NOTICE OF PROPOSED DEVELOPMENT

THREE LOT SUBDIVISION & BOUNDARY ADJUSTMENT

APPLICATION NO: 7.2023.25.1

2217 ARTHUR HIGHWAY – PROPOSED SUBDIVISION 7.2023.25.1 DRIVEWAYS

Drawing

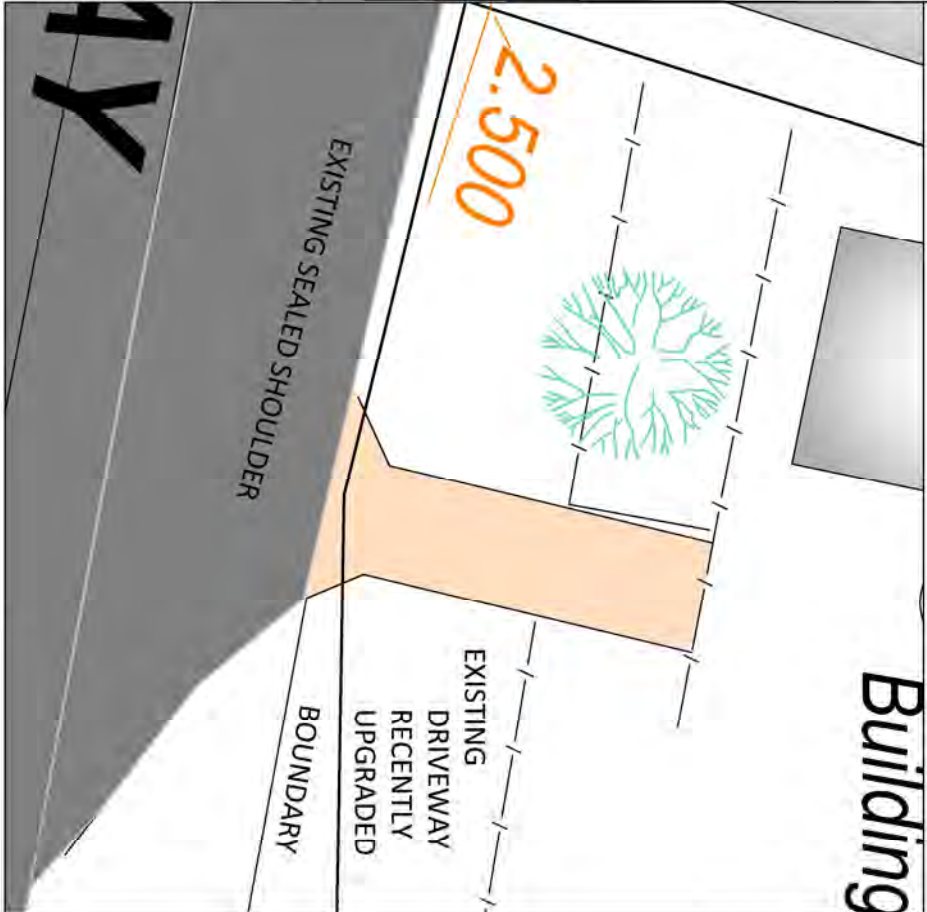
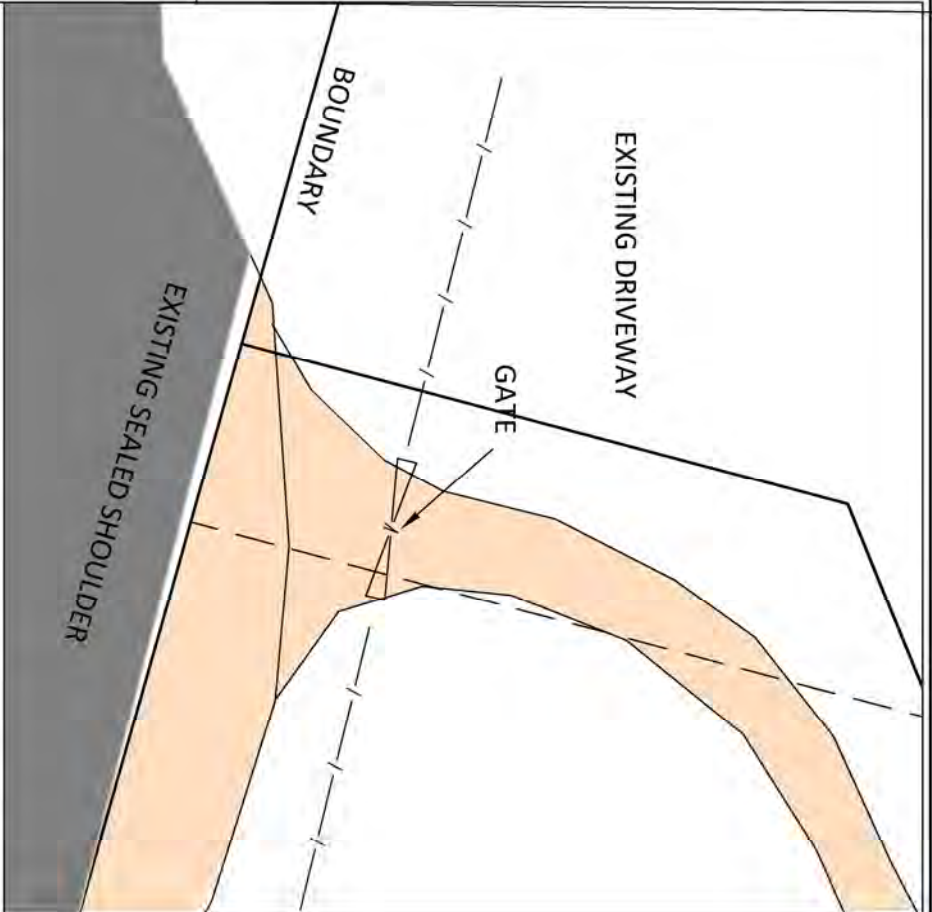
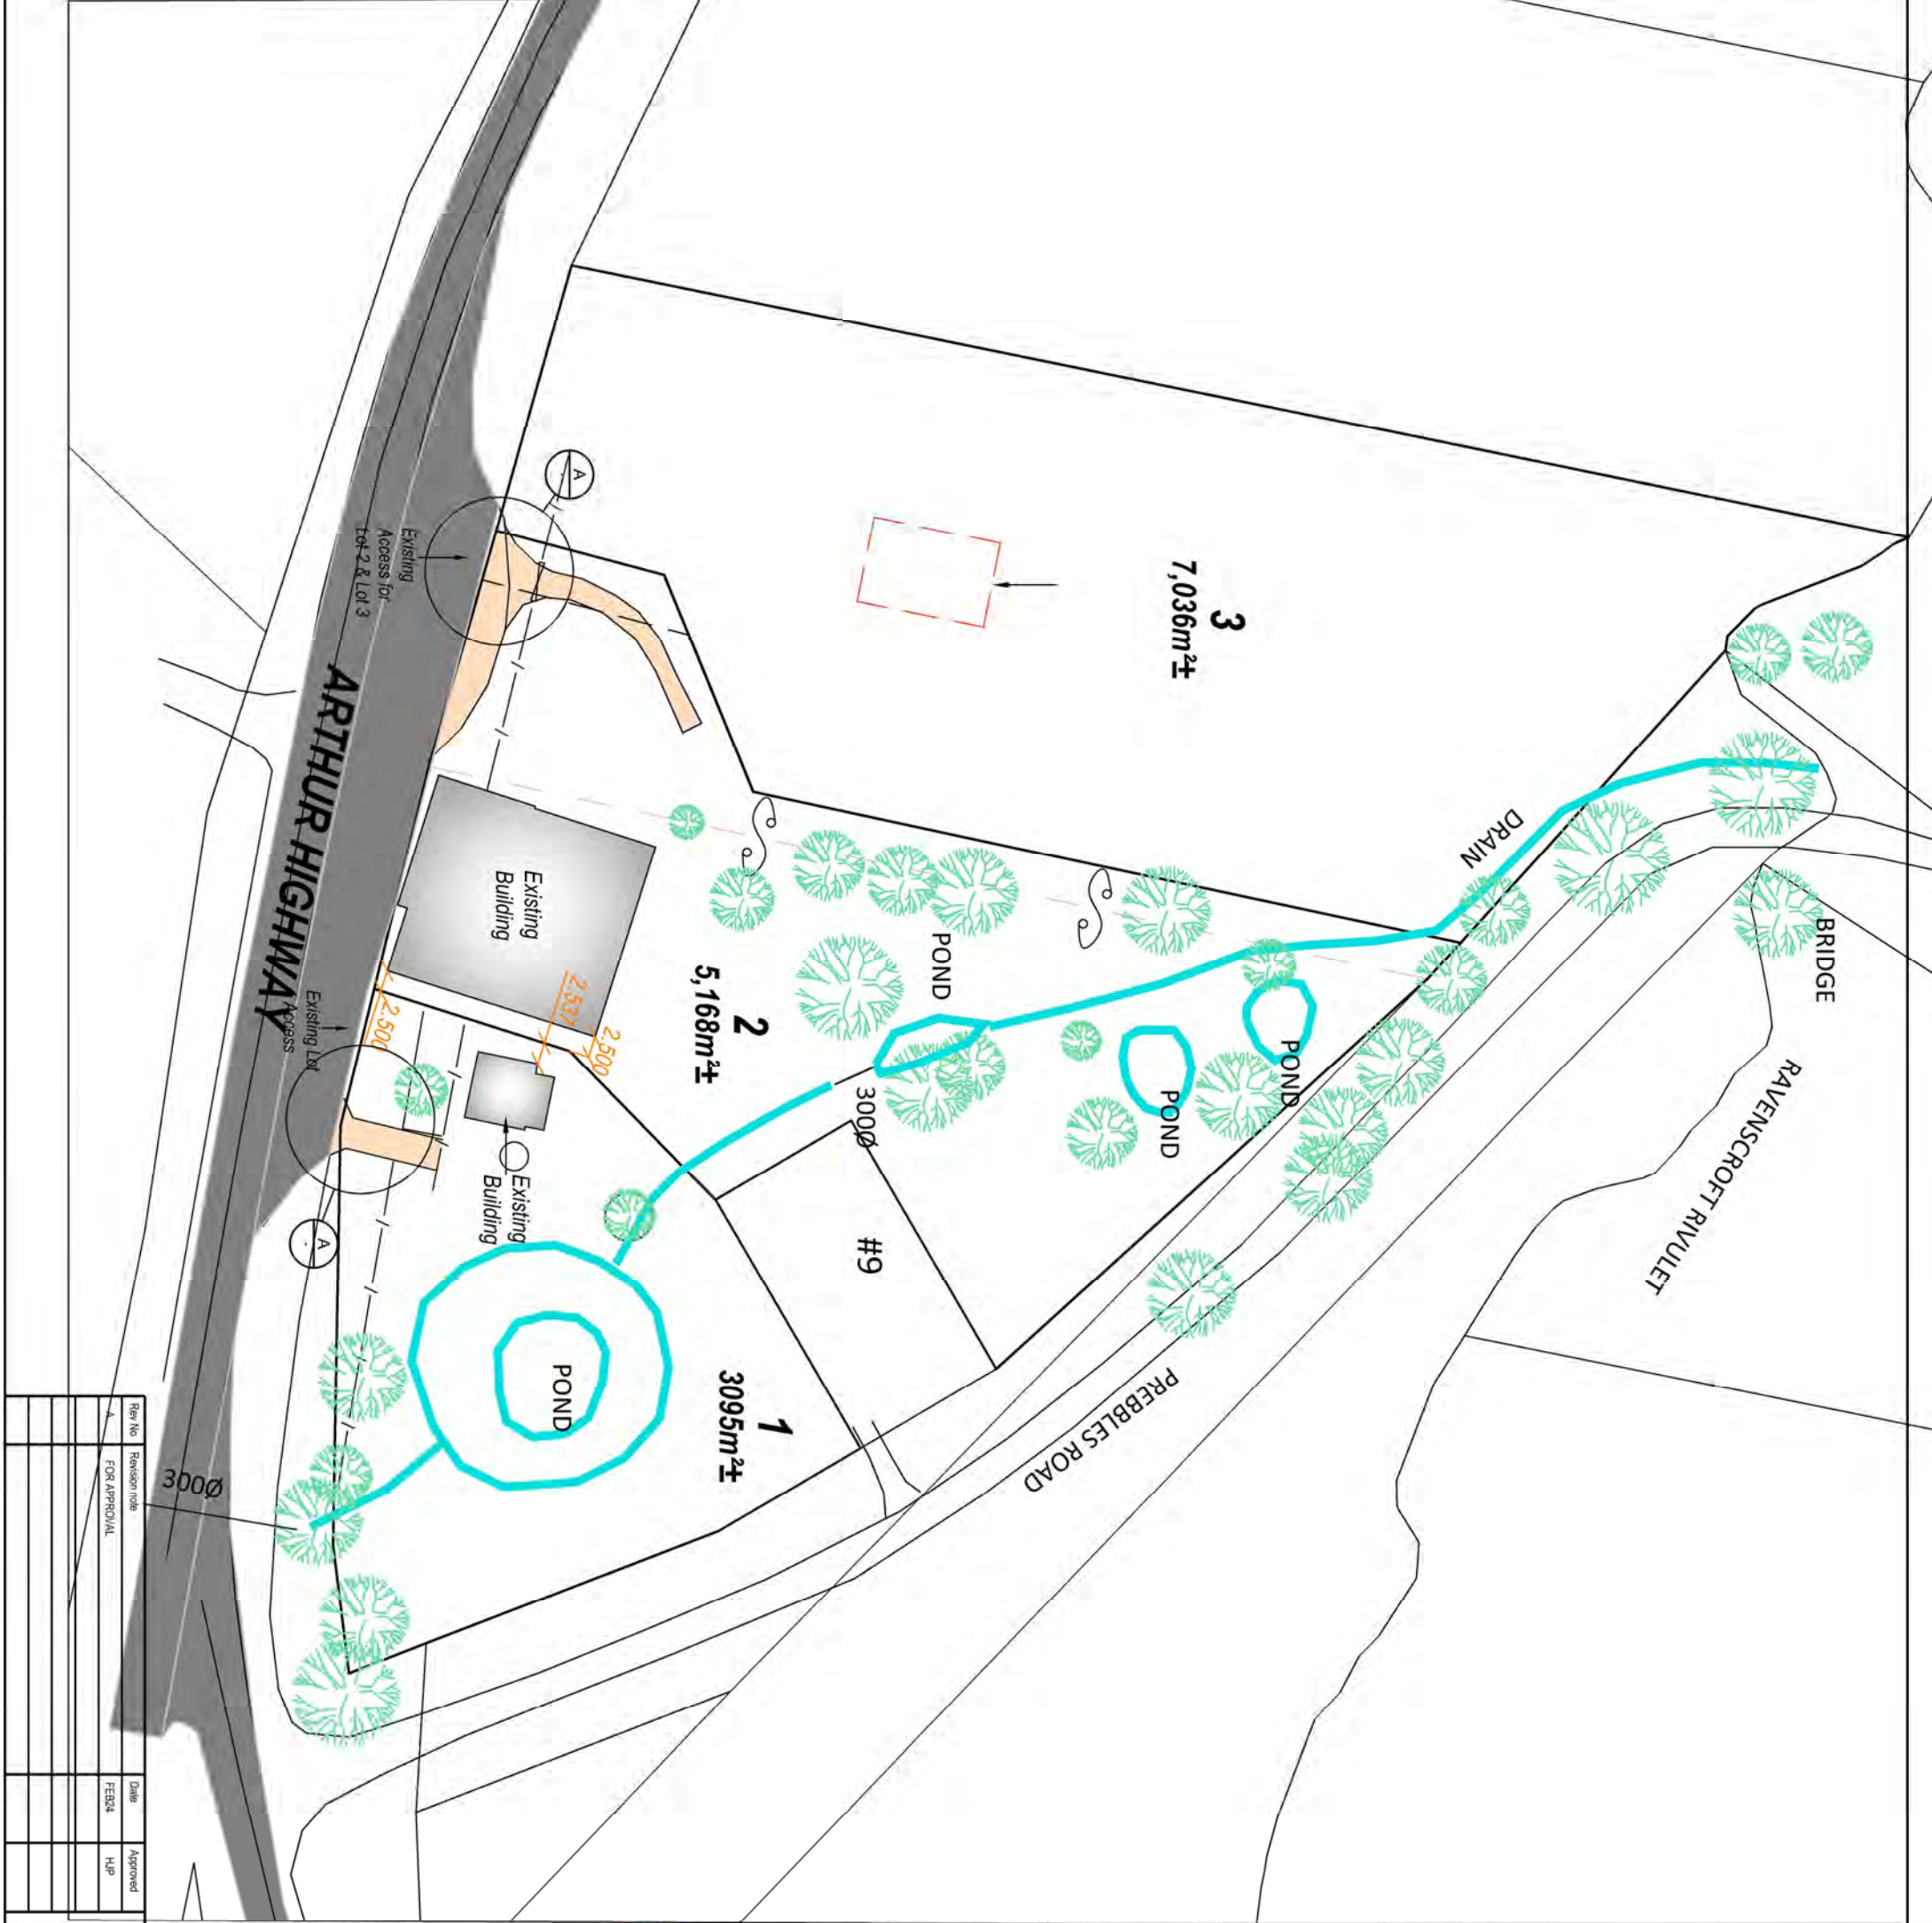
- Please demonstrate an existing approved access has been constructed in accordance with the prescribed standard 12.5.1 & C3.5.1. *Alternatively please amend the proposed plan of subdivision to denote a proposed access to lot a. It has been noted by council that land owner consent (from the crown) has been granted.*

The situation is somewhat unique as a parking area is sealed to the boundary so no works are required within the road reserve.

The driveway for lot 1 was previously a gravel/grass parking area off the sealed parking area. The owner has recently upgraded the driveway with gravel contained by an edging. There is no space to turn around within the property so a vehicle must back out onto the parking area. The parking area is 7.2m from the edge of the running lane so there is plenty of clearance.

Similarly the shared driveway to lot 2 and 3 is existing. It is sealed to the boundary. The gate is set back 6m from the boundary. There is space for two vehicles to exit and enter the driveway clear of the road.

All driveways have sight lines in excess of 110m in both directions. The posted speed limit is 60km/hr requiring a sight distance of 105m.

Drawing

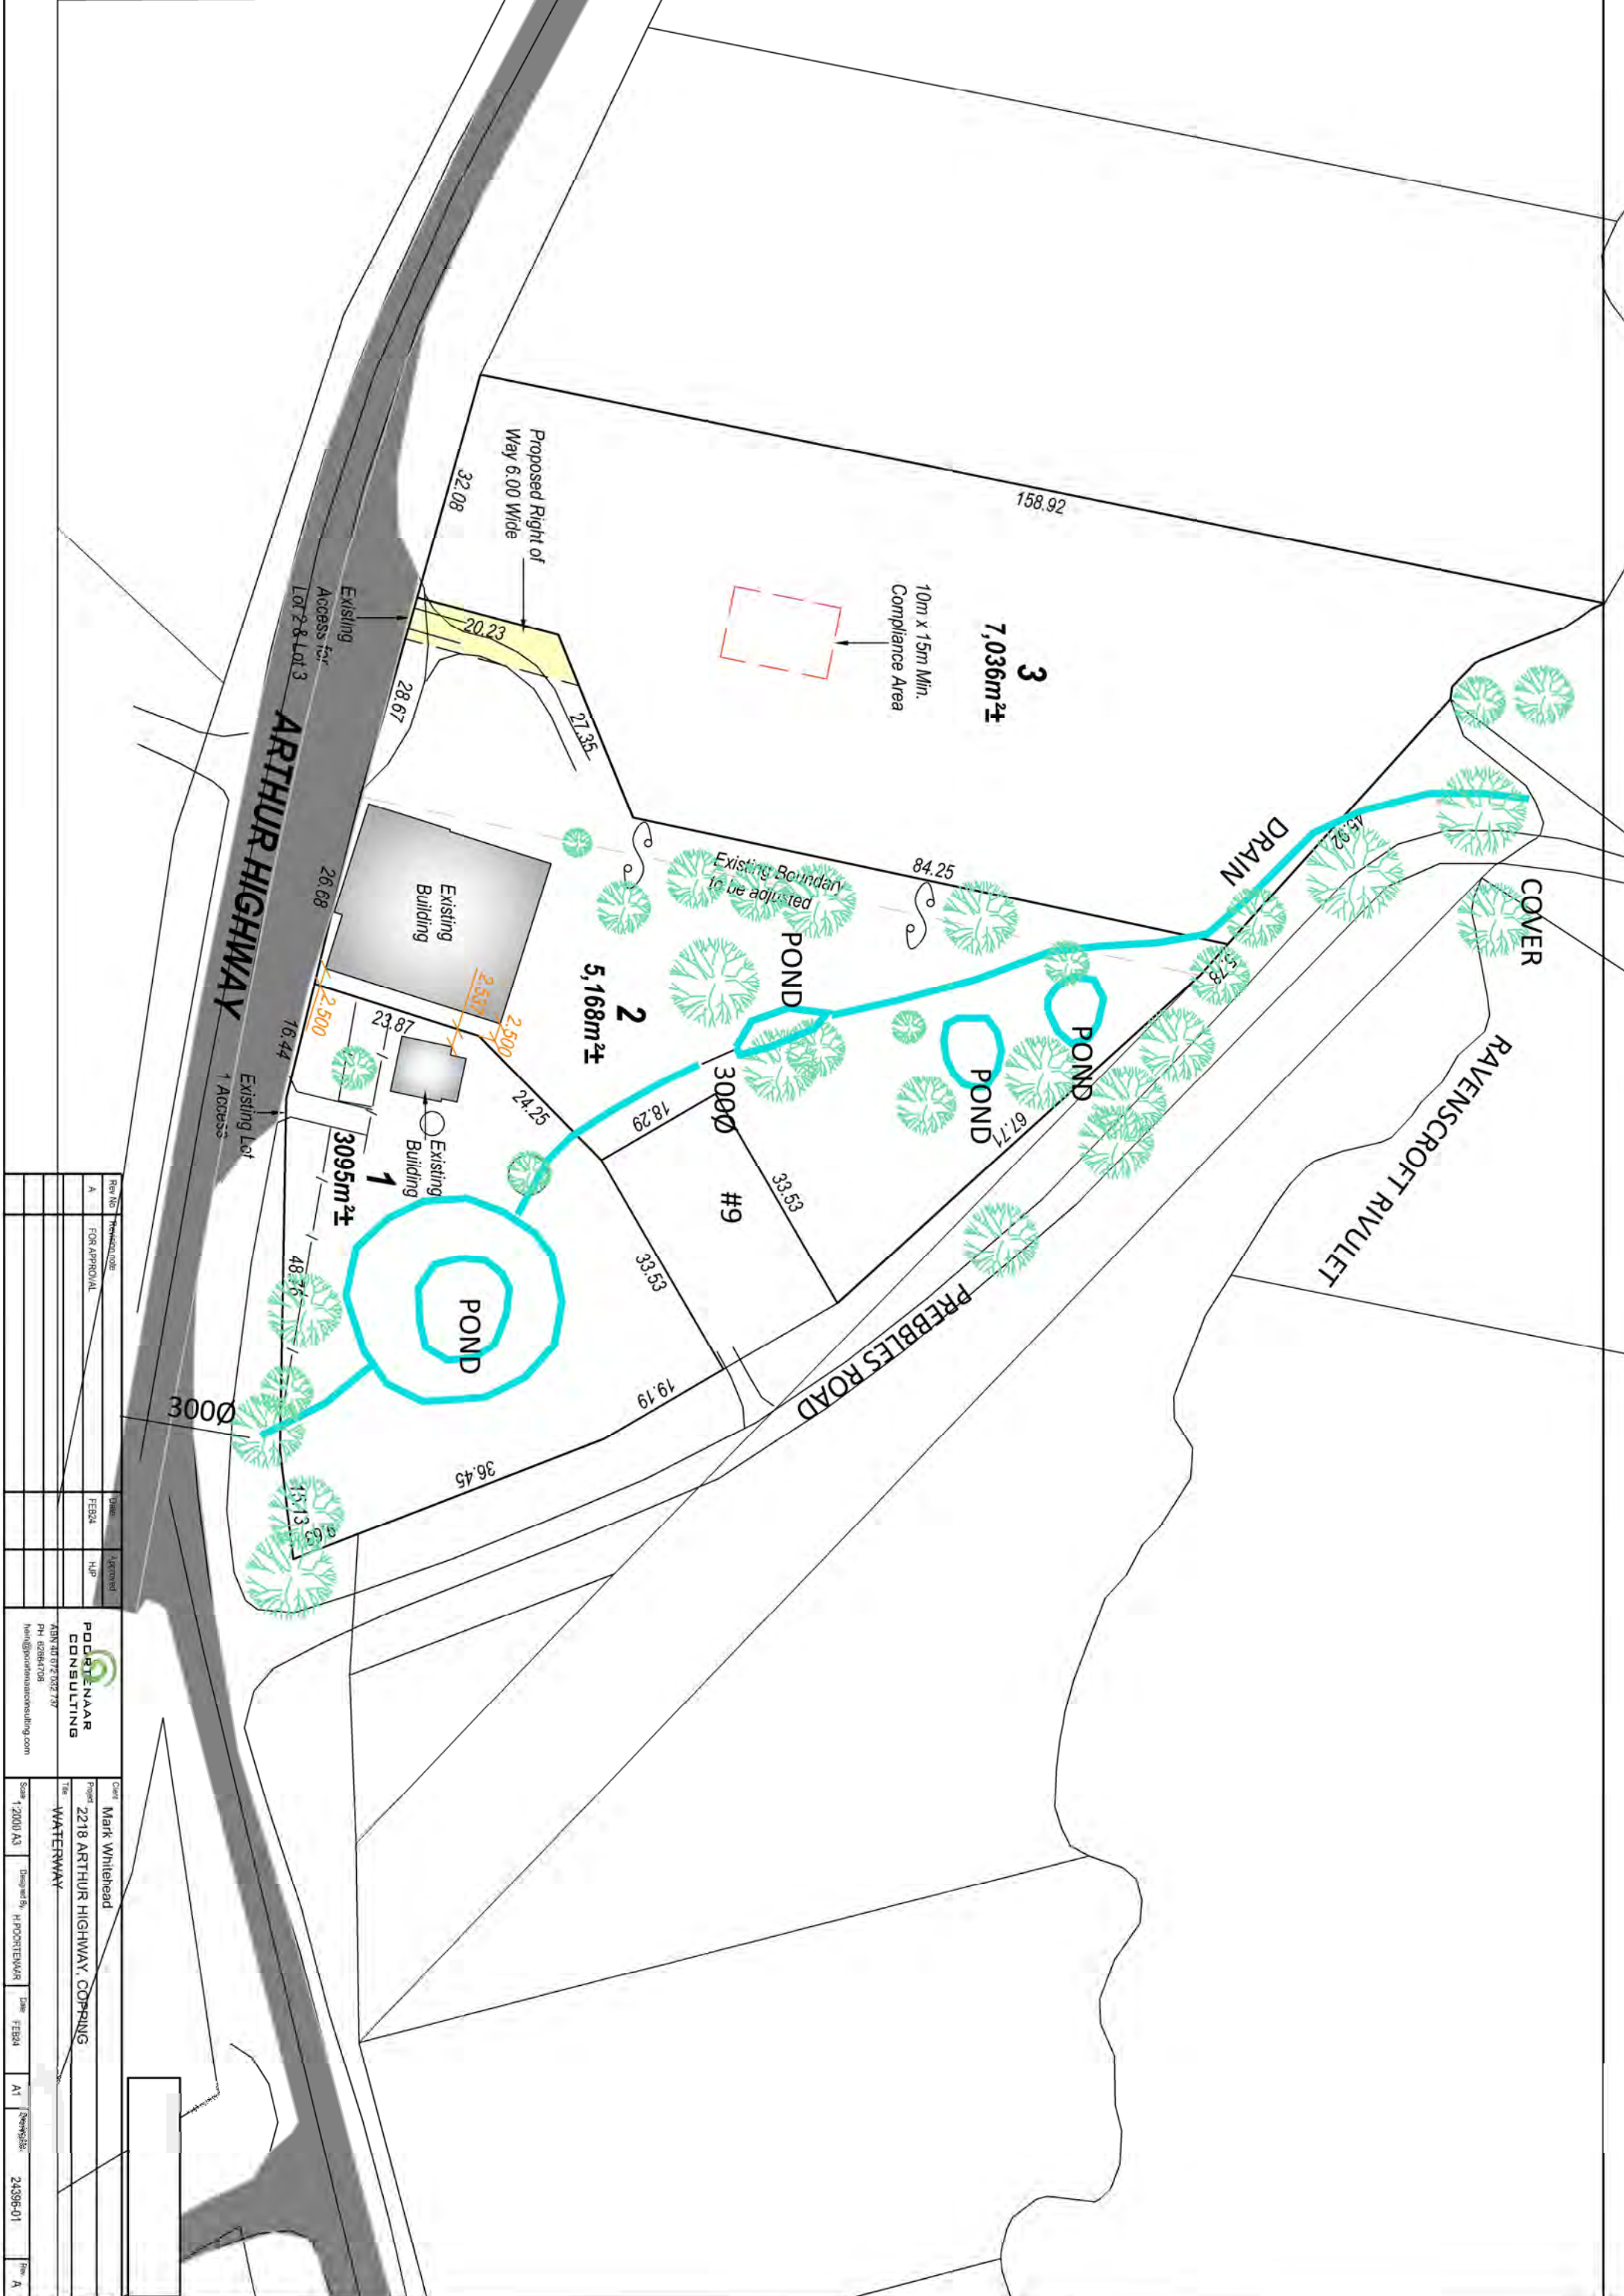
Provide a Natural values report prepared by a suitably qualified and experienced ecologist or equivalent that is:

- Prepared in accordance with the Guidelines for natural values surveys (www.nre.tas.gov.au) and has regard to clause C7.7.1 subdivision within a waterway and coastal protection area.

- the watercourse is a class 4 watercourse,
- it is normally dry, heavily modified by damming and diversions
- the area is not covered by a Biodiversity Overlay
- the development satisfies A1 of C7.7.1 that any foreseeable development is outside the waterways protection zone

Acceptable solution A1 is satisfied as the future development of any of the lots including building, services, bushfire hazard management or vehicle access will be outside the waterways protection area.
